GREAT LAKES INDIAN FISH & WILDLIFE COMMISSION

April 30, 2013

Potential impacts to wetlands due to groundwater drawdown at the NorthMet mine site

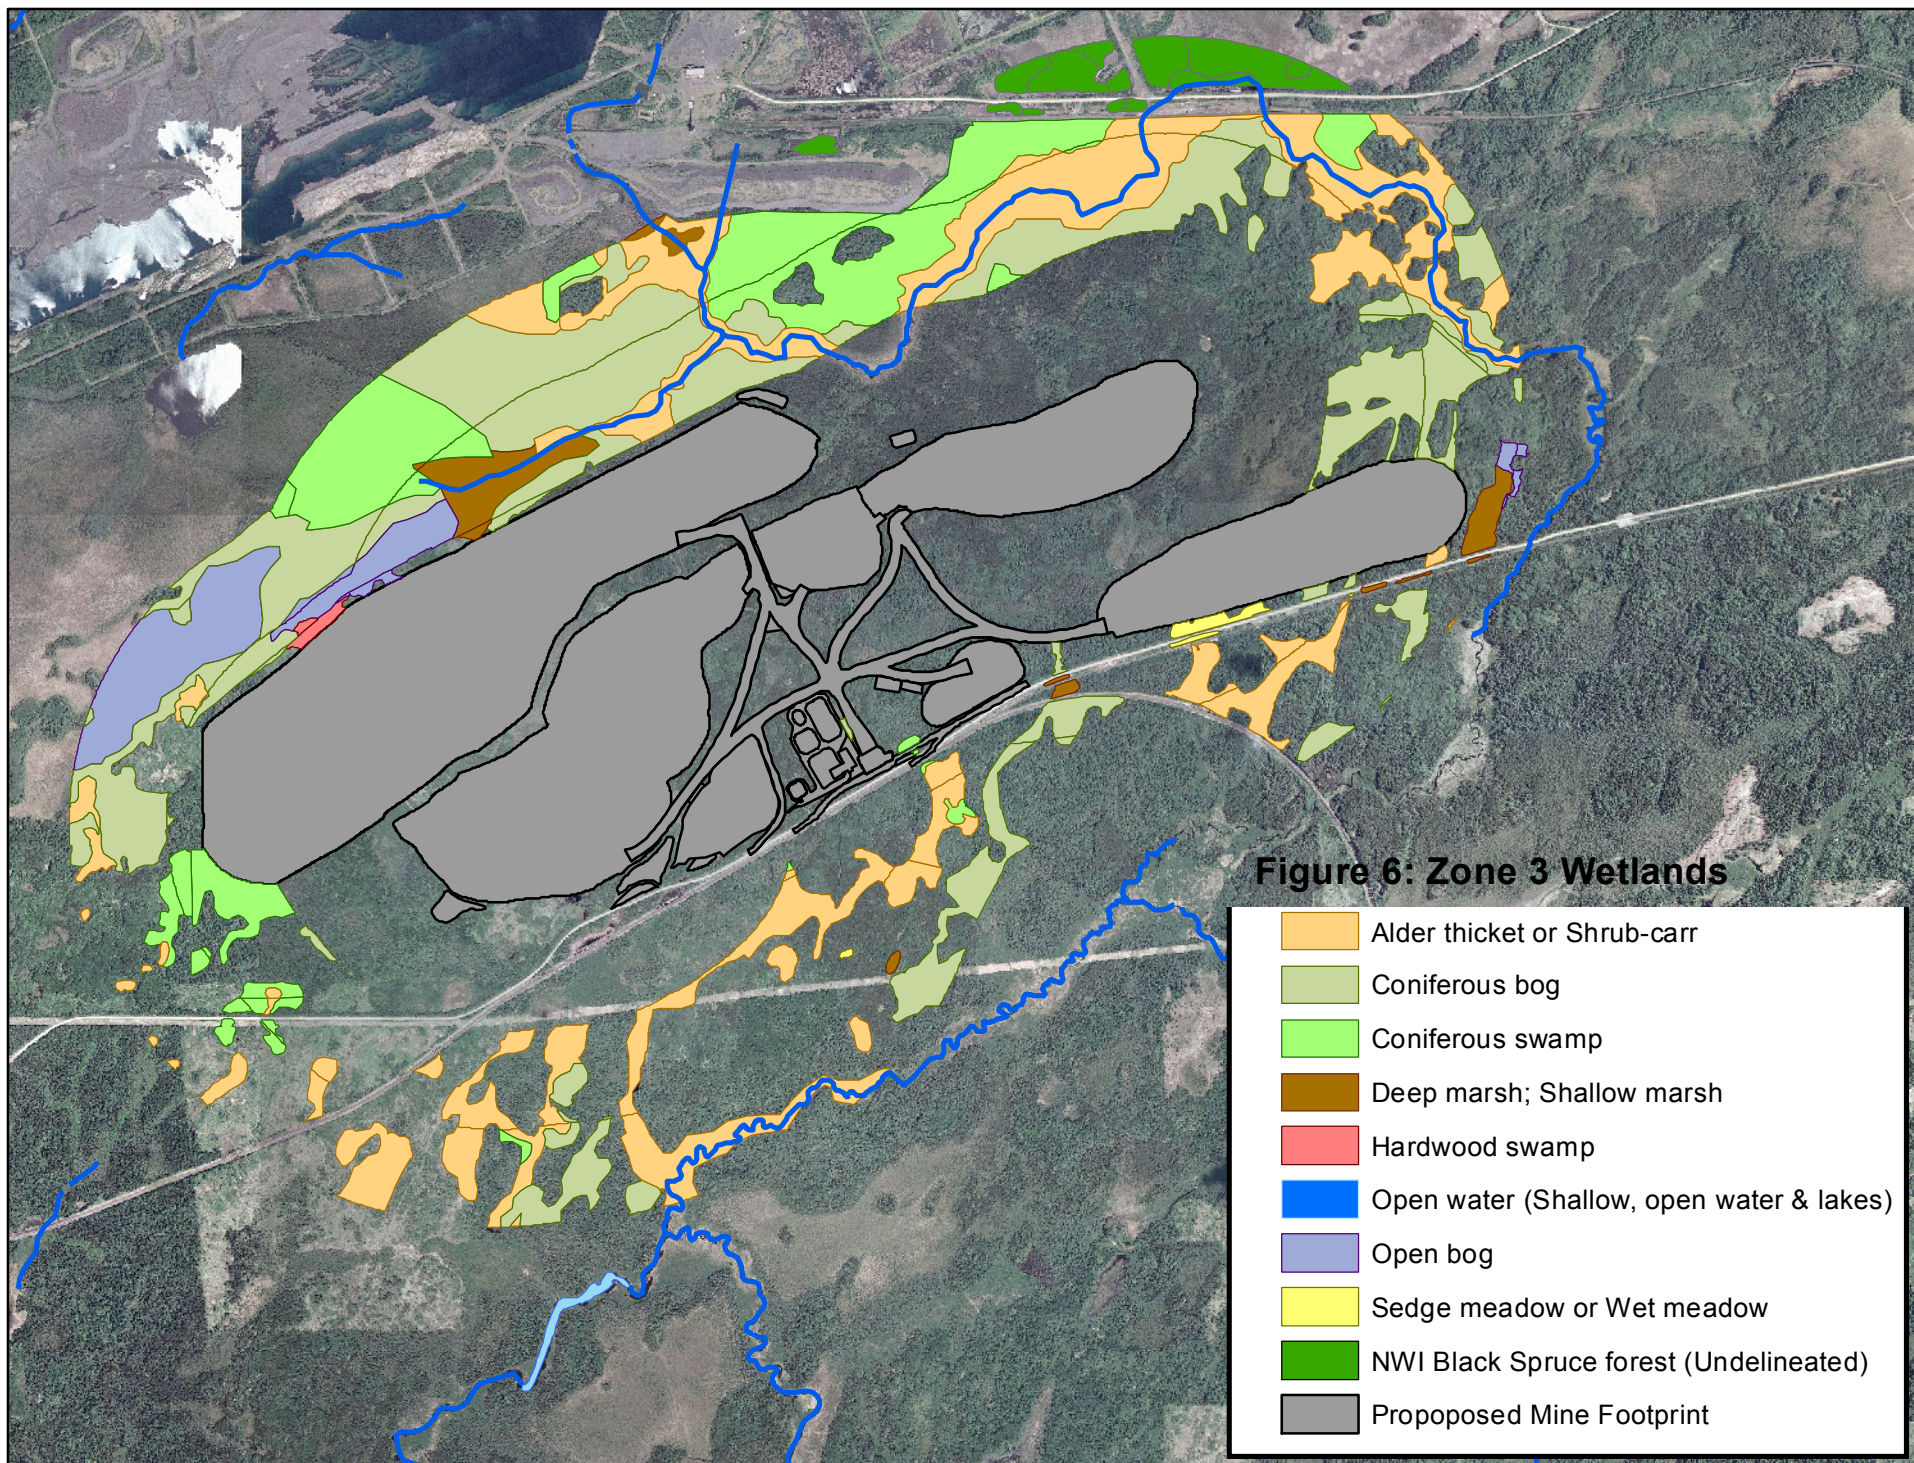
GLIFWC has modified Zone 3 in response to available data (from 2000 to 3500 feet in data package to 2000 to 5000 feet). Wetlands within zone 3 are depicted in Figure 6. The Rhino and Highway 7 wells are 2150 and 2625 feet respectively from the Canisteo pit. In response to reflooding in the pit, the Rhino well responded with a greater than 1 foot increase (Figure 7) and the Highway 7 well responded with a greater than 2 foot increase. Two additional wells provide analog information for this zone. First, the Pinto well north of Hibbing is 2112 feet from the nearest active pit shows a drop of at least 3.55 feet in response to pit dewatering. Second, a MNDNR observation well located 4224 feet from the nearest active pit at Hibtac shows a 3.5 foot drop in water level. Attachment B is a slide from a presentation given by Mr. Crotteau outlining the water level drop at this well.

These two wells are drilled into the bedrock and therefore it is not clear how those large water level drops in bedrock wells are expressed in the surficial aquifer and in wetlands. Regardless, this information fits with the analog approach of the lead agencies for NorthMet and illustrates that pit induced groundwater drawdowns can be expected to extend well into zone 3. The analog information suggests that drawdowns of 1 to 3.5 feet can be expected throughout zone 3. The impact assessment for zone 3 wetlands is provided in Table 3.

Most of the east west reach of the Partridge River on the north side of the mine pits is within zone 3. As previously suggested, 1 to 3.5 feet of drawdown could be a significant impact to the hydrology of the river. In addition, the City of Keweenaw wells indicate that drawdowns of tens of feet in the bedrock aquifer below the Partridge River are likely. This potential hydrologic impact should be assessed as part of the NEPA process. Finally, reductions in flow to the Partridge River could indirectly impact riparian wetlands downstream.

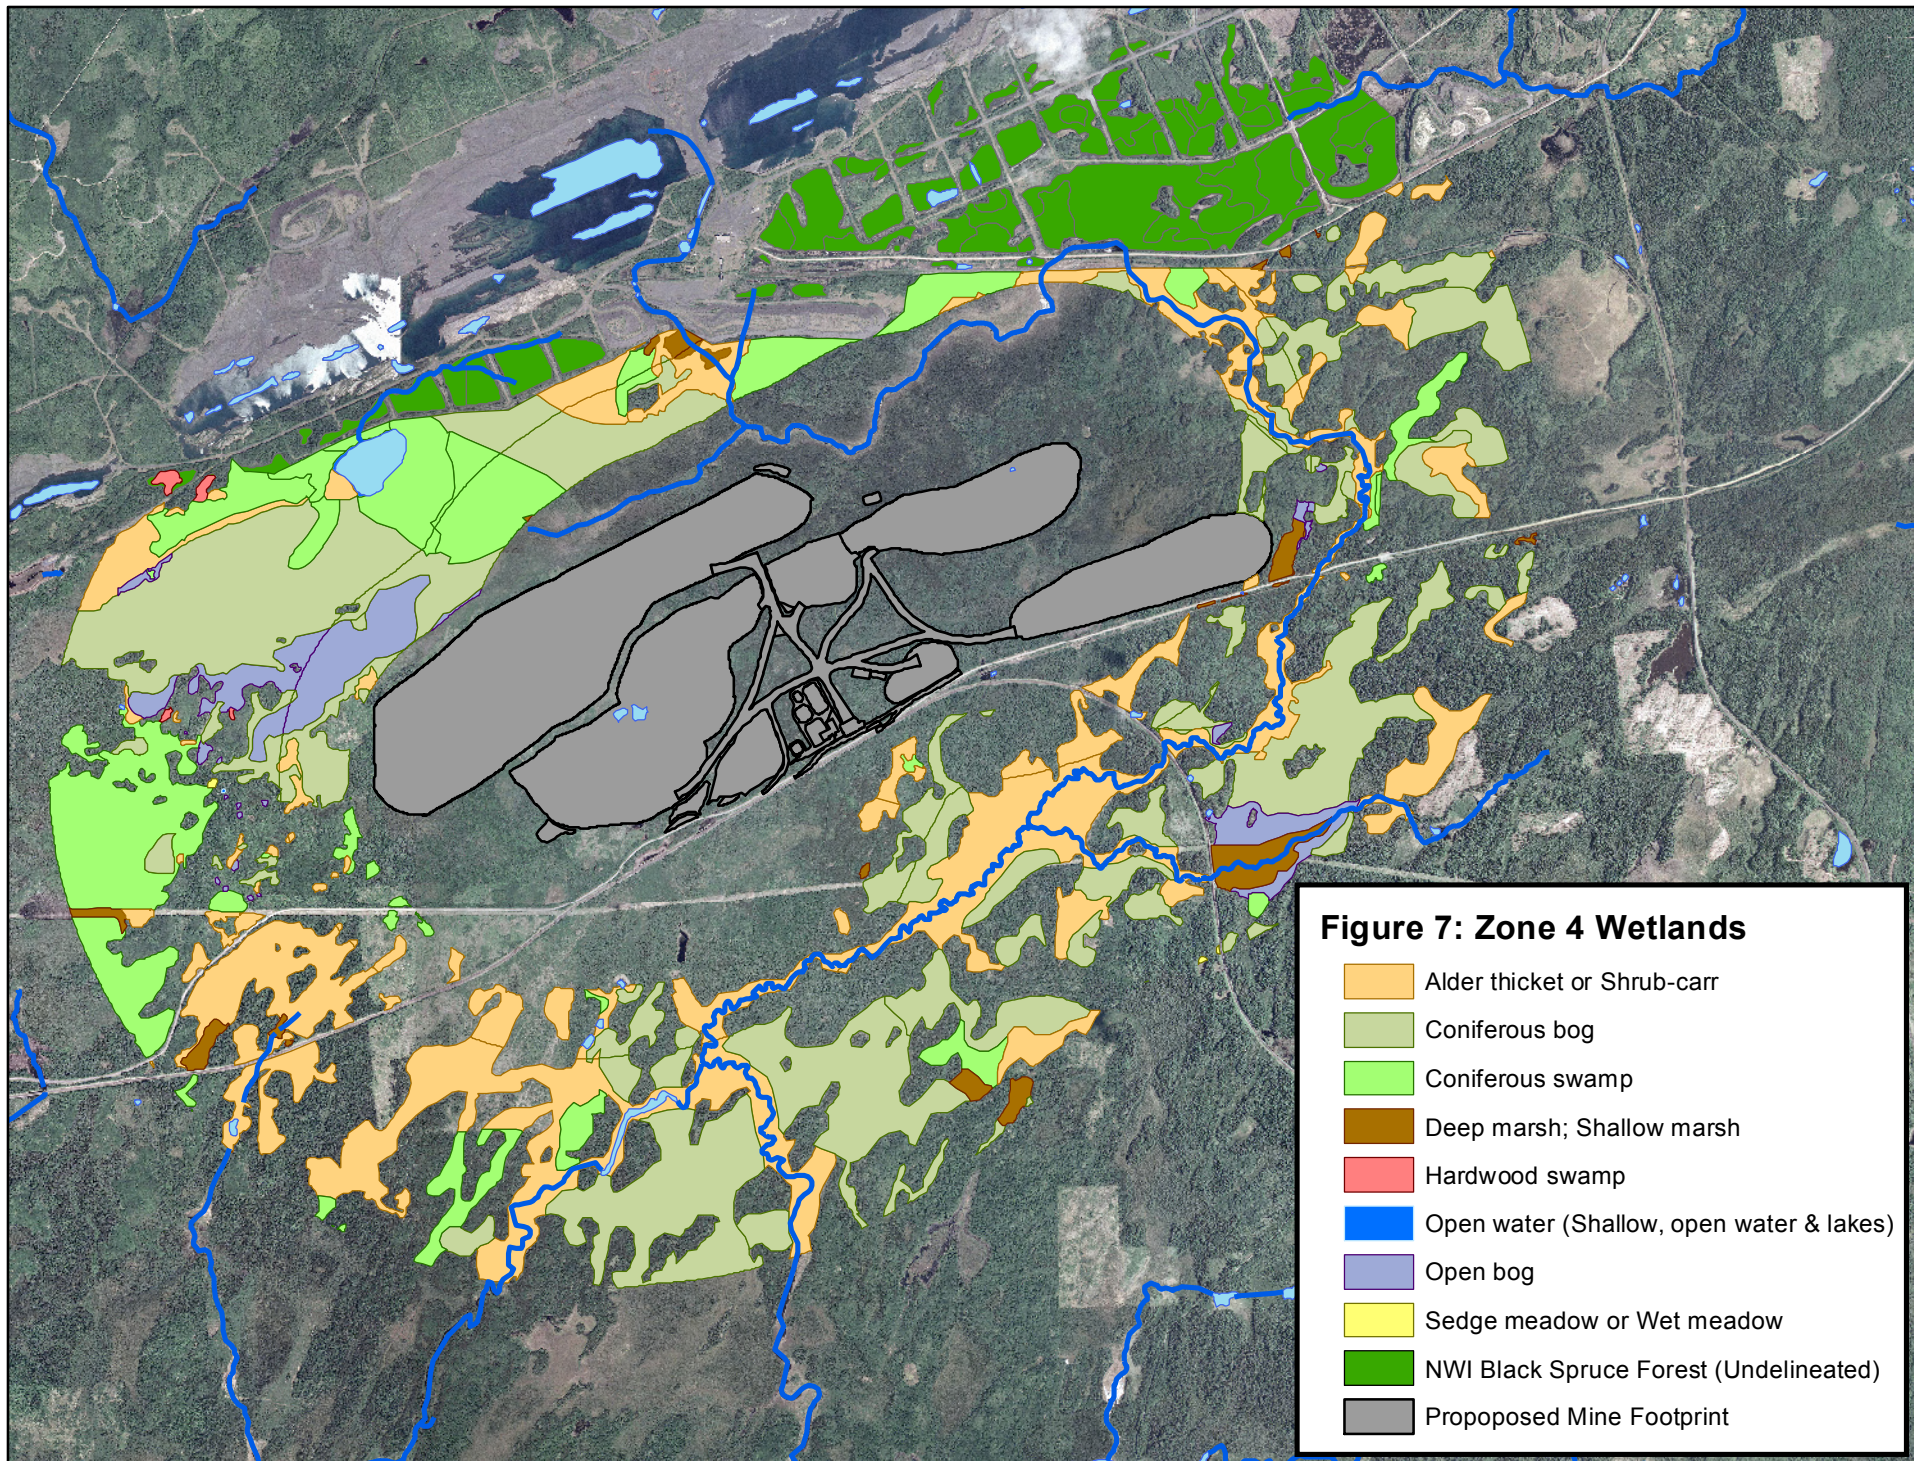
Wetlands within zone 4 are depicted in Figure 7. There is no well data that can be used to draw conclusions about mine pit related drawdown in this zone. Based on Zone 3, it is reasonable to assume that 0 to 1 feet of drawdown would occur under wetlands within this zone.

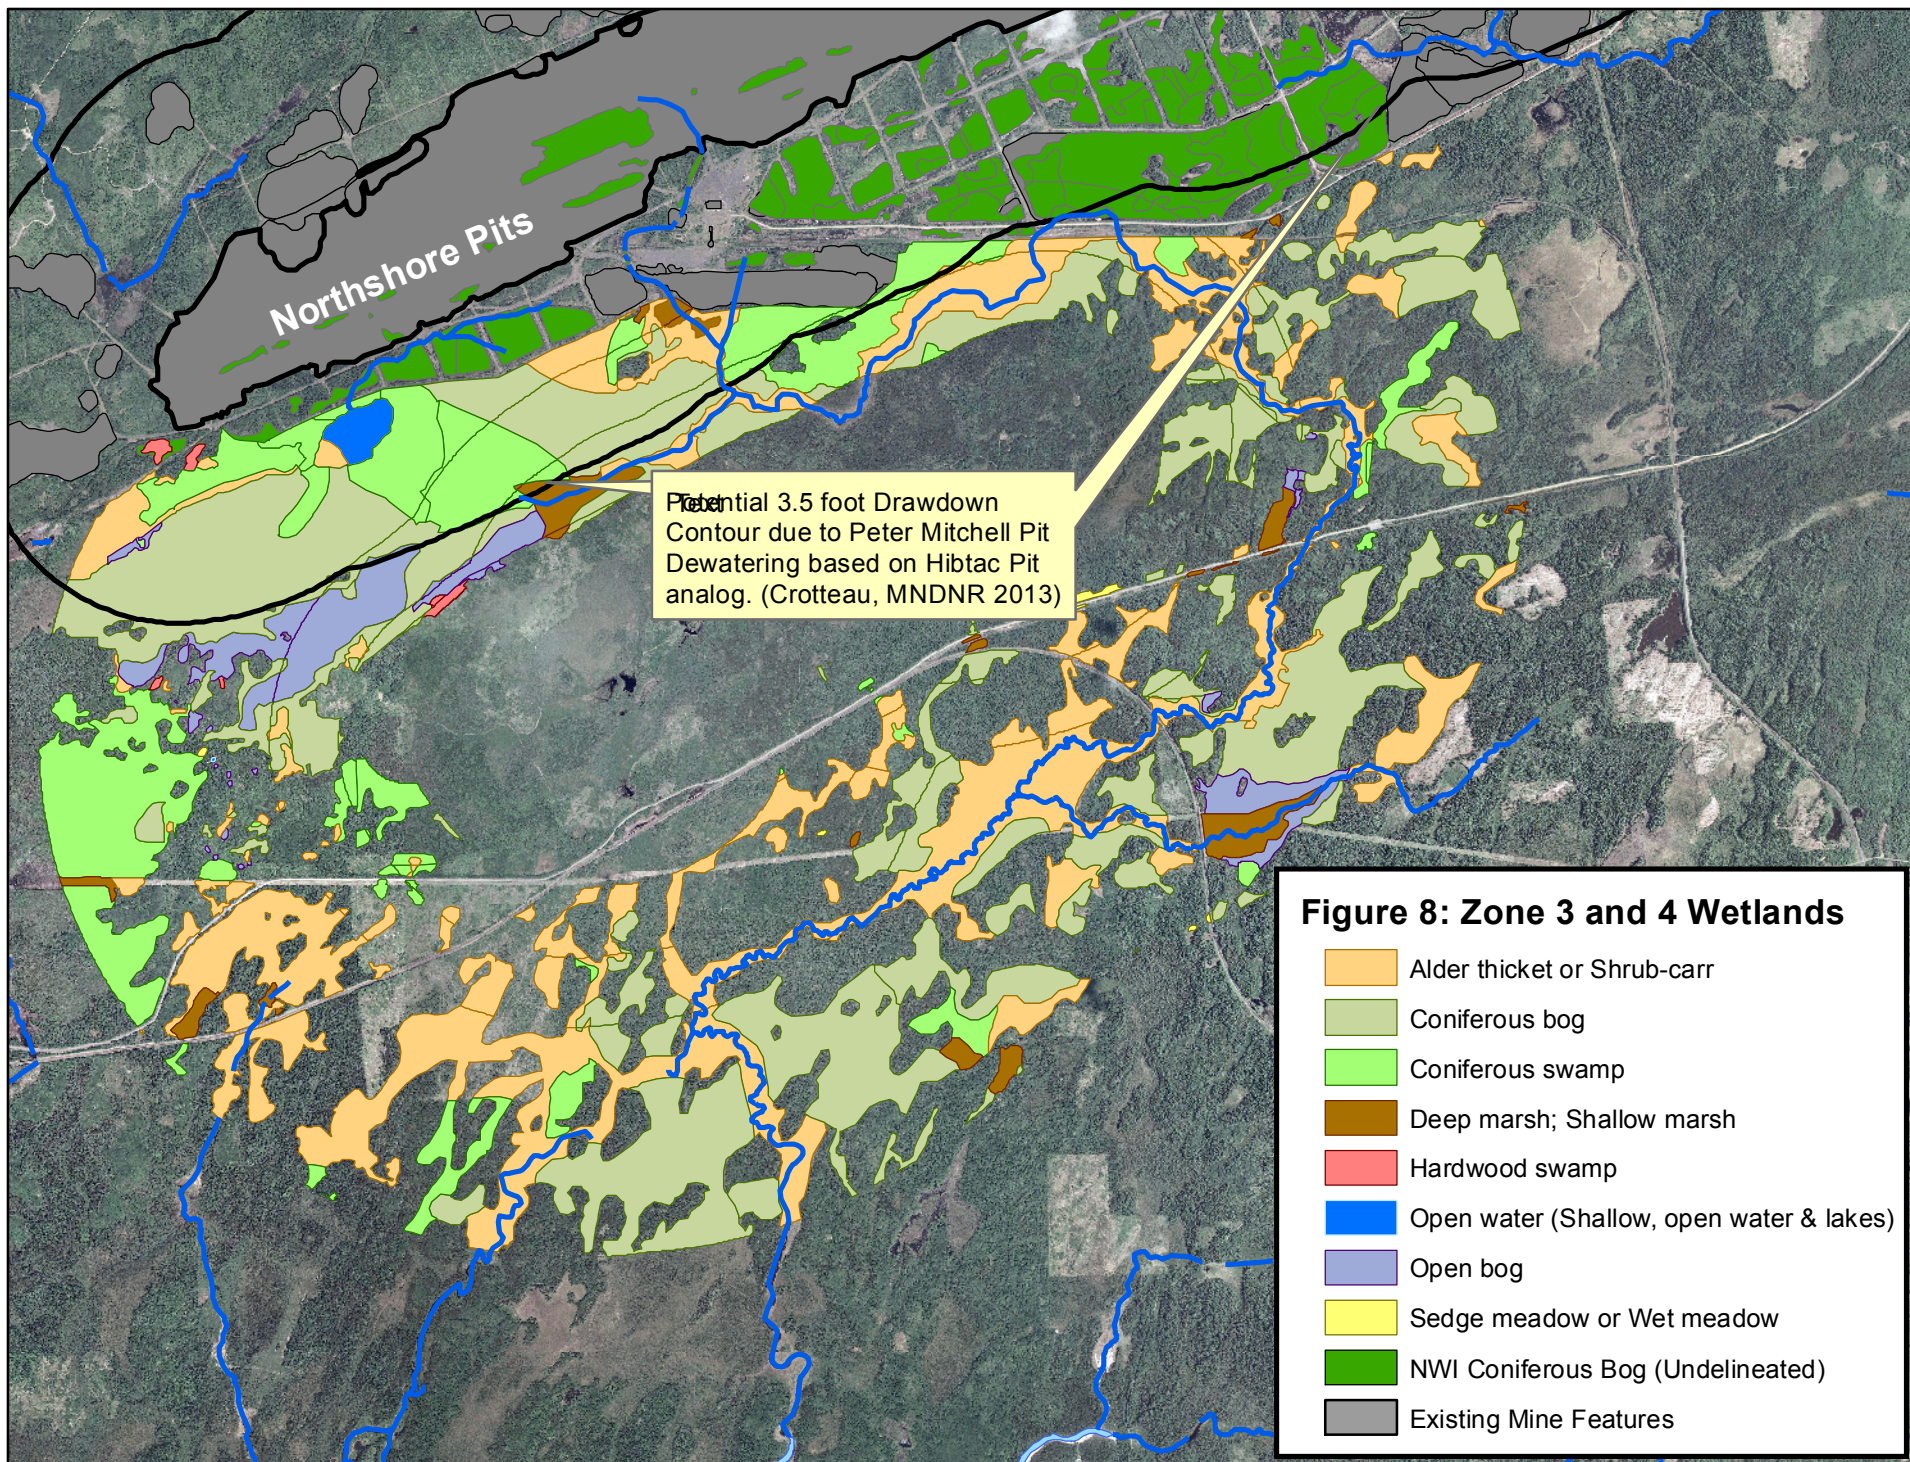
Zone 3 wetlands on the north side of the mine pits are also subject to impacts related to the dewatering of the Peter Mitchell pit. Figure 8 illustrates the possible extent of drawdown impacts at the Peter Mitchell pit based on the Hibtac well data provided by the MNDNR Mining Hydrologist Michael Crotteau. This cumulative effect is not included in version 7 of the data package and should be analyzed. Therefore, GLIFWC is assuming that the analog information also applies to the Peter Mitchell pit and assumes that wetlands to the north are impacted by both projects.

As discussed above zone 4 wetlands on the north side of the proposed mine pits are also subject to impacts related to the dewatering of the Peter Mitchell pit (Figure 8).
